SUBJECT: COMANCHE PEAK STEAM ELECTRIC STATION (CPSES)
DOCKET NO. 50-446
TRANSMITTAL OF INSERVICE INSPECTION PROGRAM PLAN
INTERIM CHANGE REQUEST

INTERIM CHANGE REQUEST

Plan Title/Rev. Unit 2 Inservice Inspection Plan Rev. 3 ICR No. ISI-2R3-01

**CPSES UNIT 2
RELIEF REQUEST
C-4**

TCX-2-1180

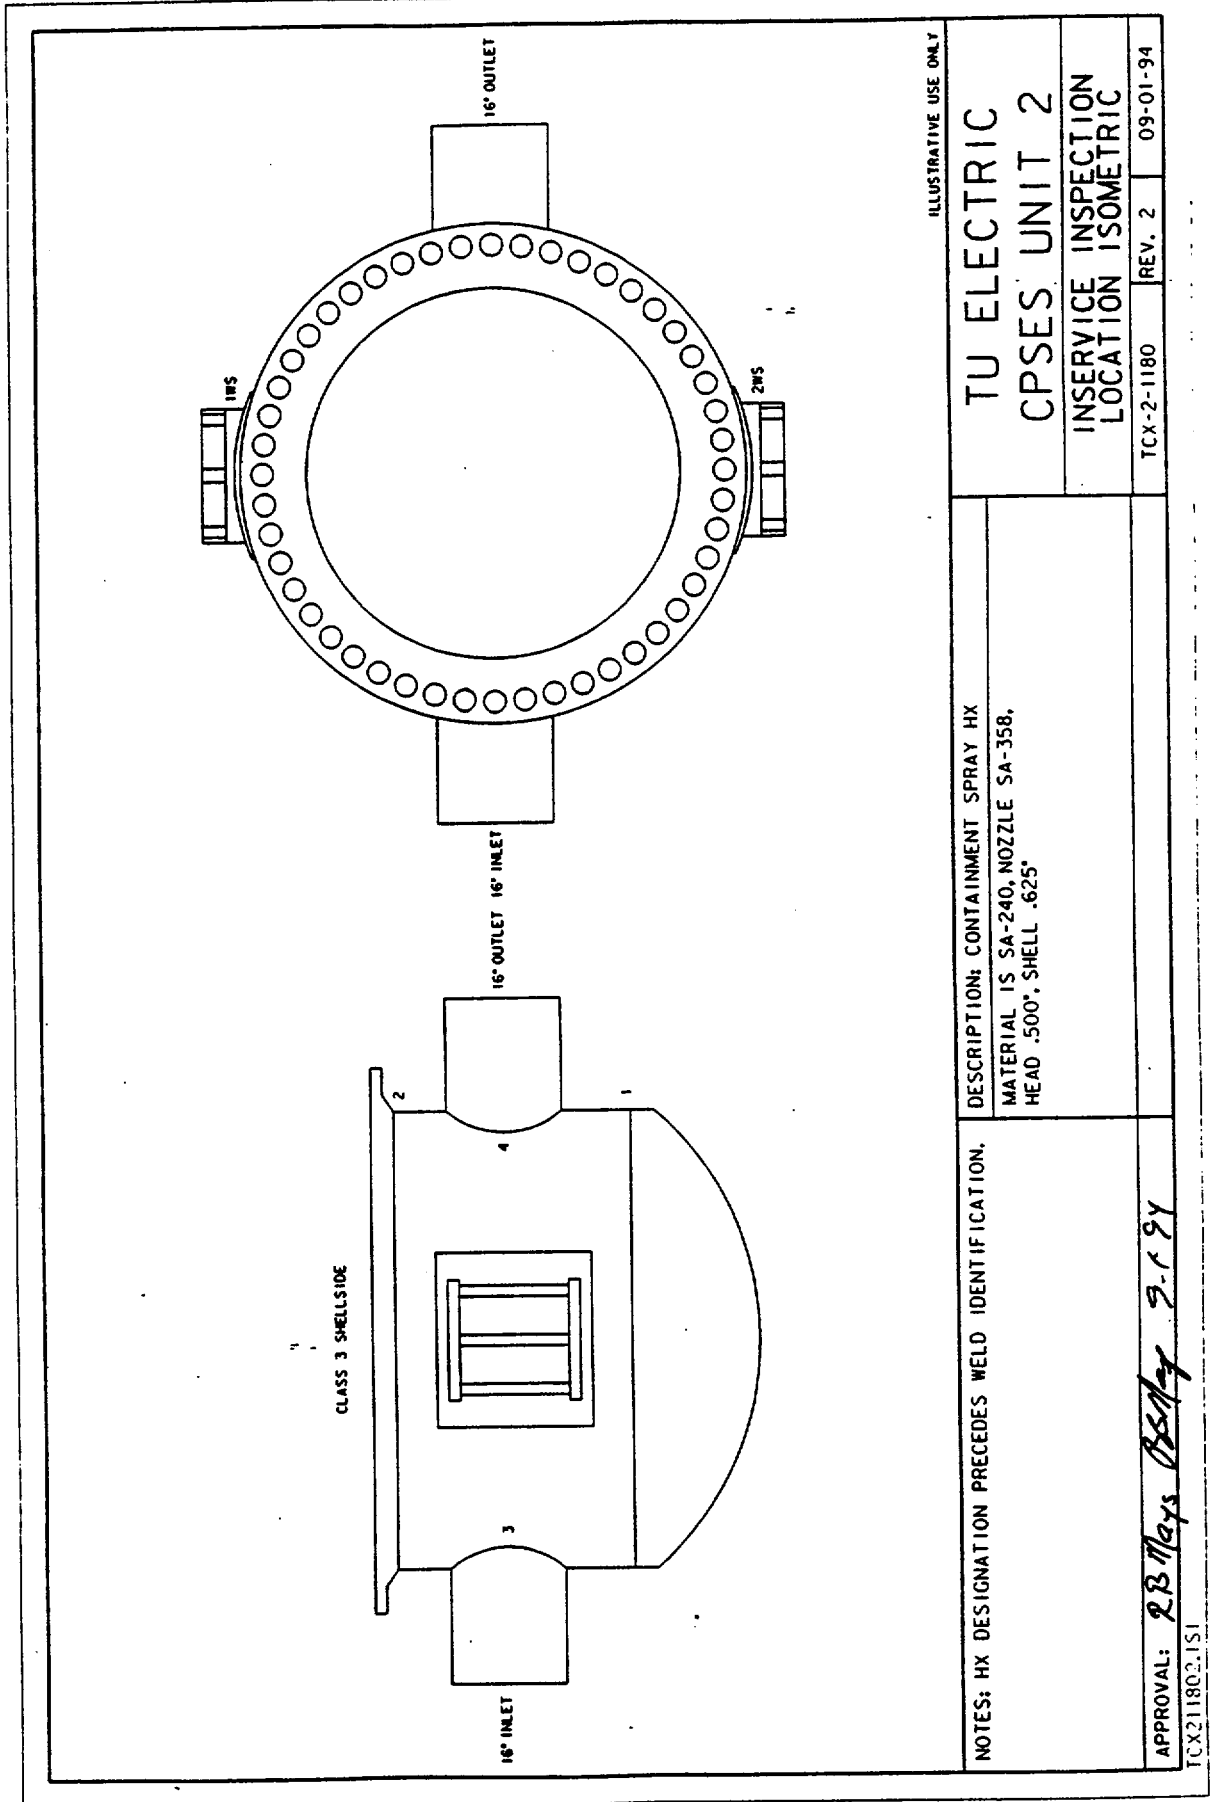
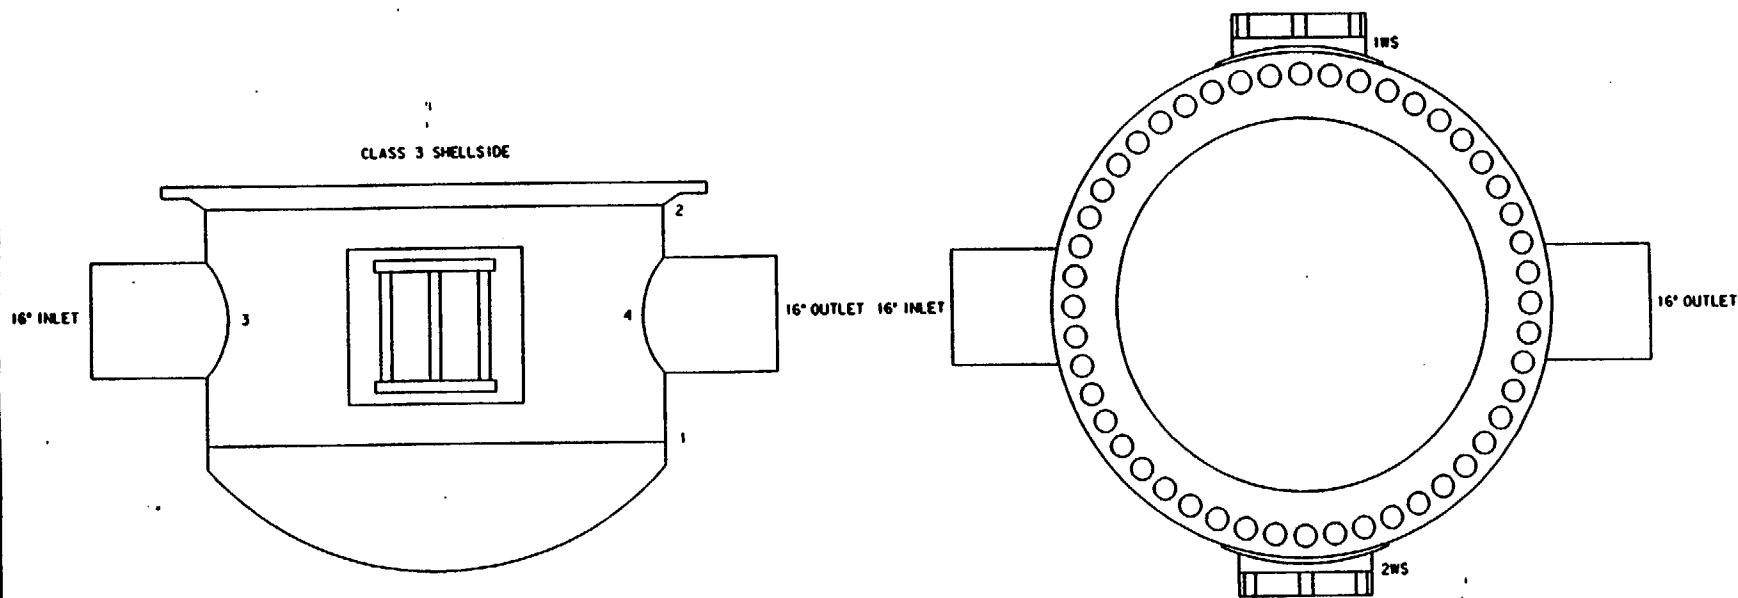
For weld TCX-2-1180-1-2, interferences from the heat exchanger welded support pads preclude the complete ultrasonic examination of the volume required by Fig. IWC-2500-1. Approximately 14% of the weld length did not receive the full code required examination coverage. See pages 2 and 3 for weld location and examination area configuration for weld TCX-2-1180-1-2.

There were no recordable indications identified by the best effort volumetric examination performed on the accessible portions of the weld length.

COMPONENT ID TCX-2-1180-1-2

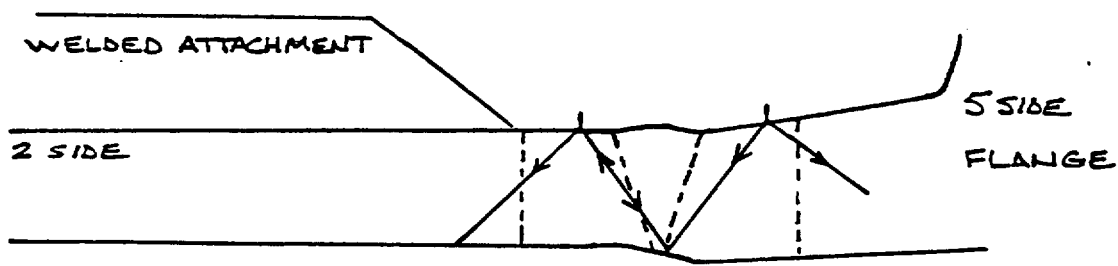
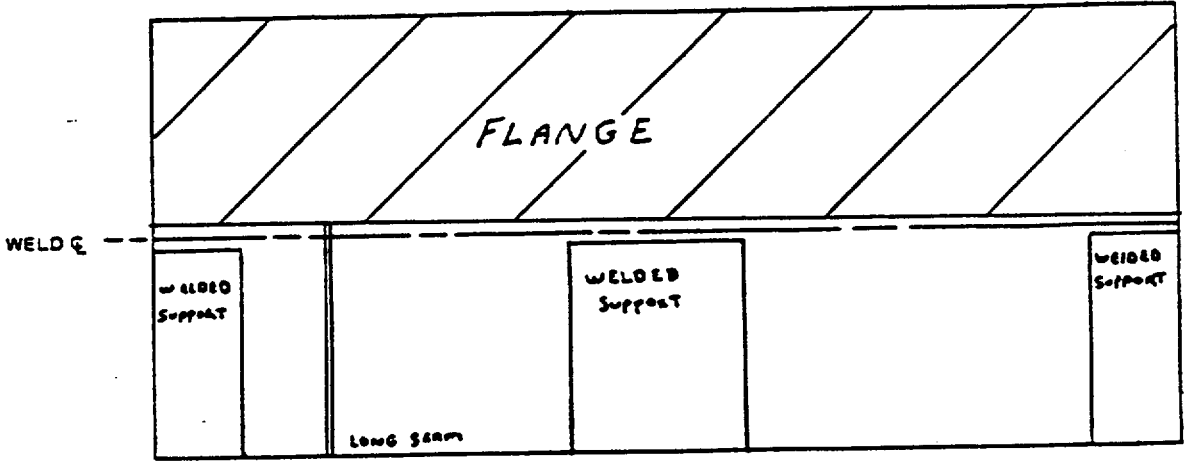
14% NOT EXAMINED DUE TO WELDED SUPPORTS.
